Re: Stibnite Gold Project DEIS #50516

Dear Supervisor Linda Jackson and Chief Vicki Christiansen,

Screenshot from DEIS, Appendix D: Restoration Design Sheets, Drawing G5, 5 of 139.

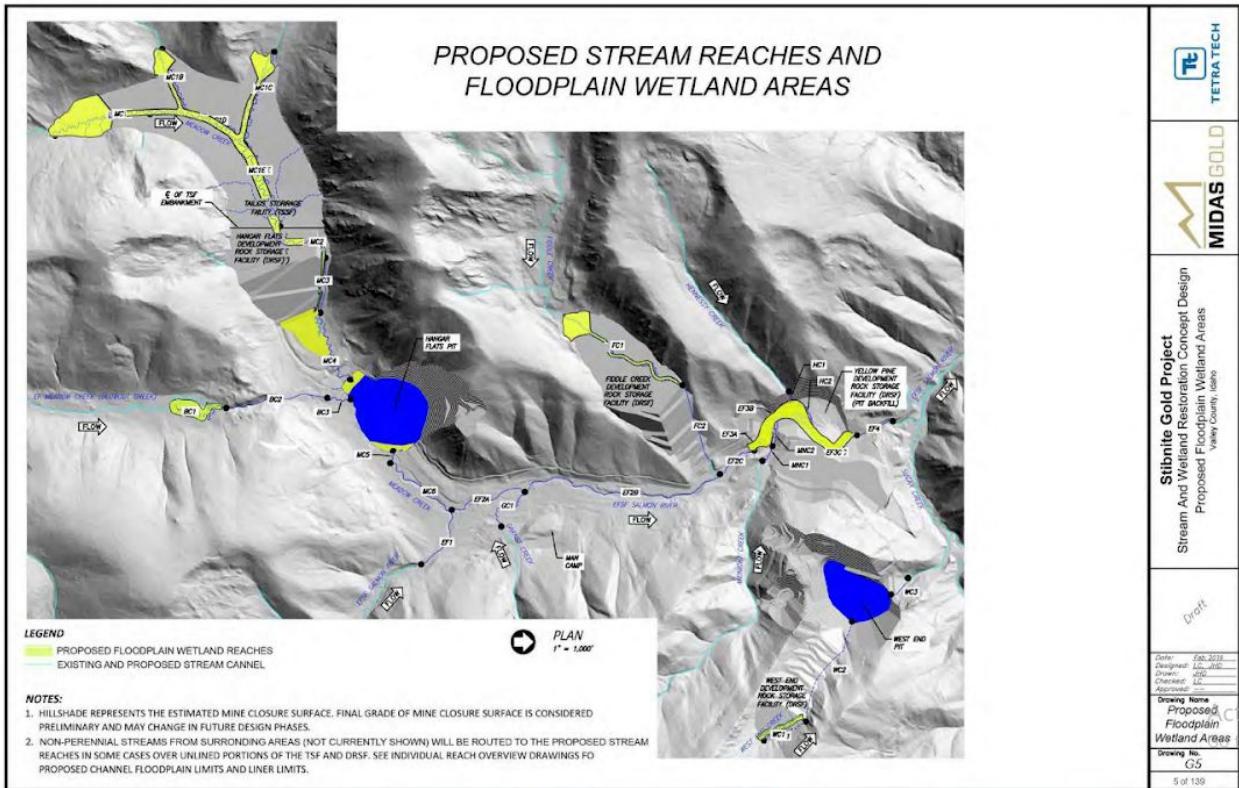
It is easy to get lost in the details of this report and start to feel like the company will be able to mitigate a lot of the concerns regarding water pollution and impacts to the ecology (especially fish). However, I encourage you to take a big picture view of this project. At its core, this project proposes to store mine tailings in the bottom of valleys, reconfiguring the landscape to create hanging valleys of mine tailings (see CAD drawings in Appendix D of the DEIS, also copied below). The biggest issue with storing huge amounts of mine waste in the bottom of valleys, is that this is precisely where water collects and it is the flow of water through these tailings that will mobilize and collect contaminants. Although they propose a system of drainage pipes and liners that are supposed to keep these contained, viewed on a legacy timeline of generations the water will win and this will release contaminants downstream. Furthermore, they propose making a steep channel along the face of the tailings pile to connect the restored and elevated wetland area to the river channel below. Basically, they are creating a huge drop in elevation which creates a 'knickpoint', a point of an increase in kinetic energy and focal point for erosion. Are we really sure that the channel that is proposed will be able to be maintained for posterity? Has Midas adequately addressed this issue? At some point in the future, I would not be surprised if the water starts eroding the face of the tailings piles¹. Also, I have serious doubts that fish would be able to navigate upstream of the tailing piles to access the restored wetland areas on top- so you will lose the areas upstream of the tailings piles as habitat for migratory fish².

5. The proposed tortuously meandering planform is out of character with existing stream reaches. The proposed grade of the top of the tailings is really flat. A stage 0¹⁶ type restoration scheme would be more appropriate in this location.

6. The plan has meander bends butting up against the edge of their inset floodplain. Putting the outside of a meander bend at the edge of your lined floodplain is asking for trouble since this is where most erosion happens¹⁷.
